Technical Service Bulletin

74 Rear center armrest lid does not latch

74 13 09 2018004/3 September 13, 2013. Supersedes Technical Service Bulletin Group 74 number 08-06 dated December 5, 2008 for reasons listed below.

Figure 1. The release handle (1), lugs (2), holes (3), spring (4) and mountings (5).

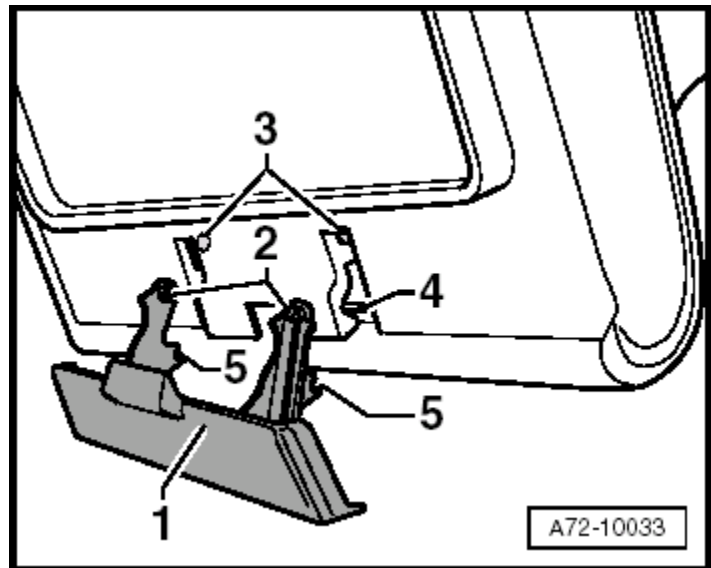
Unfavorable tolerance between the release and the armrest.

Improved release button with additional stop.

1. Use a screwdriver to carefully press the lugs (Figure 1, 2) out of the holes (Figure 1, 3).
2. Detach the spring (Figure 1, 4) from the mountings (Figure 1, 5).
3. Take off the release handle (Figure 1, 1).
4. Carefully feed the lugs (Figure 1, 2) of the replacement release button into the holes (Figure 1, 3).
5. Attach the spring (Figure 1, 4) in the mountings (Figure 1, 5).
